»» Service Letter

Number: L08-03 C

Subject: Lifting of TBO Limitation on SAC52001 Rev J Castings

Engine Application: Teledyne Continental 470, 520, and 550 engines

Figure 1: SAC52001 Rev J Casting - FAA Approved for Full TCM TBO

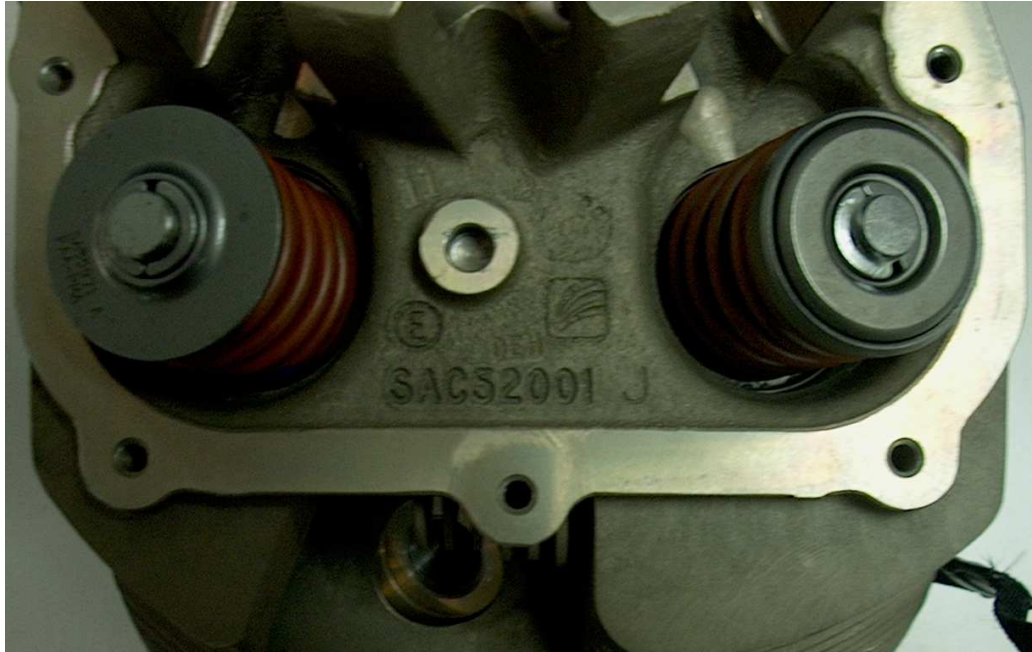
Superior has successfully completed requalification testing of the subject cylinder head casting. FAA Approval has been received and full TCM TBO is again granted to all Superior PMA replacement cylinder assemblies listed in the table below, regardless of cylinder head casting revision level.

The figures below identify the configurations of Superior cylinder heads used on the TCM 470/520/550 replacement cylinders, both of which are now approved for full TCM TBO.
